R & G PLACE SUBDIVISION, **RESUBDIVISION OF LOT 2**

APPLICATION NUMBER 3 DATE February 3, 2021

REQUEST Subdivision

DETAIL SITE PLAN

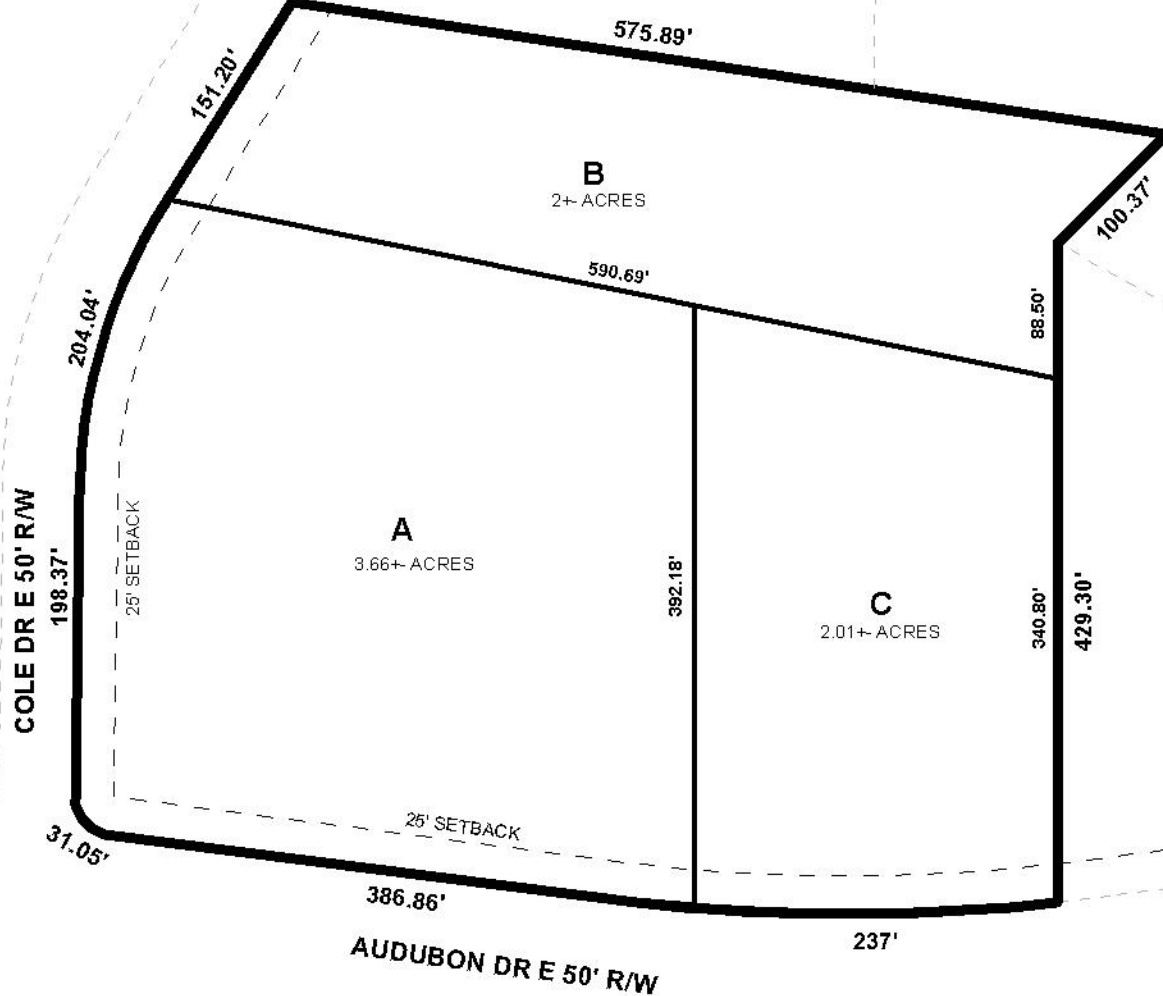
The site has frontage on Audubon Drive East and Cole Drive East, both of which are minor streets. The preliminary plat indicates a 50' width. Although neither have curb and gutter, as there was no dedication required for the previously-approved subdivision to provide 30' from the centerlines of the streets, no dedication should be required for the current subdivision.

As on the preliminary plat, the 25' minimum building setback line along both street frontages should be retained on the Final Plat, if approved.

The lot size labels in both square feet and acres should be retained on the Final Plat, or a table should be furnished on the Final Plat providing the same information.

As proposed, Lot B exceeds the maximum width-to-depth ratio of Section V.D.3. of the Subdivision Regulations. It should be noted that long, narrow lots are common in this area, and the Planning Commission has approved several properties with this configuration in the area. As such, waiver of Section V.D.3. of the Subdivision Regulation may be appropriate.

Regarding access management, a note should be placed on the Final Plat stating Traffic Engineering comments, if approved.

With a waiver of Section V.D.3., the plat meets the minimum requirements of the Subdivision Regulations and is recommended for Tentative Approval subject to the following conditions:

- 1) retention of the 25' minimum building setback line along both street frontages on the Final Plat;
- 2) retention of the lot size labels in both square feet and acres on the Final Plat, or the furnishing of a table on the Final Plat providing the same information;
- 3) compliance with the Engineering comments: (*FINAL PLAT COMMENTS (should be addressed prior to submitting the FINAL PLAT for review and/or signature by the City Engineer): A. Provide all of the required information on the SUBDIVISION PLAT (i.e. signature blocks, signatures, certification statements, written legal description, required*
